# UNITED STATES PATENT AND TRADEMARK OFFICE

APPLICATION NO.	FILING DATE	FIRST NAMED INVENTOR	ATTORNEY DOCKET NO.	CONFIRMATION NO.
10/586,557	09/14/2006	Morten Dahl	502424.117549	5741
29540	7590	03/17/2010	EXAMINER	
DAY PITNEY LLP			MAI, TIEN HUNG	
7 TIMES SQUARE			ART UNIT	
NEW YORK, NY 10036-7311			PAPER NUMBER	
			2836	
			NOTIFICATION DATE	
			DELIVERY MODE	
			03/17/2010	
			ELECTRONIC

<b>Office Action Summary</b>	<b>Application No.</b> 10/586,557	<b>Applicant(s)</b> DAHL ET AL.	
	<b>Examiner</b> TIEN MAI	<b>Art Unit</b> 2836

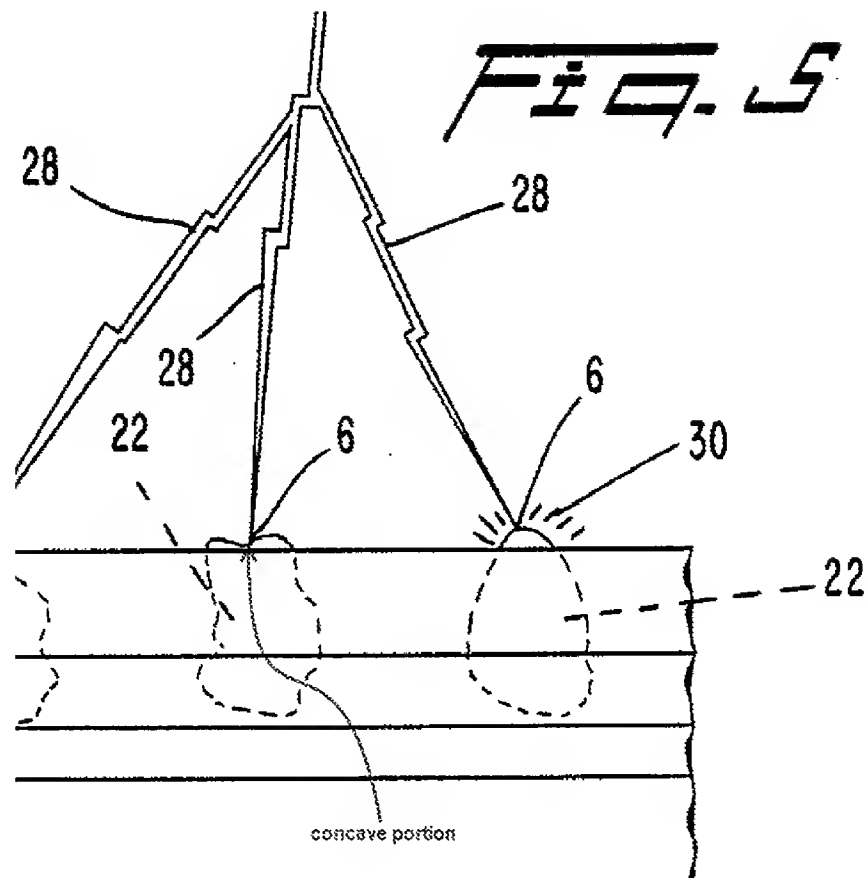
3. According to Dictionary.com defines concave as "having at least one interior angle greater than 180°"; therefore, at least exposed part of the isolated segment of Brick are concave shape. See figures below.

4. Applicant argues that the exposed part of each of Brick's isolated segments is not concave when seen from a top view. While it is true that when seen from a top view the exposed part of the isolated segment is not concave; however, as shown in Figs. 3 and 5, the exposed parts of each of the isolated segment are concave when seen from a side view.
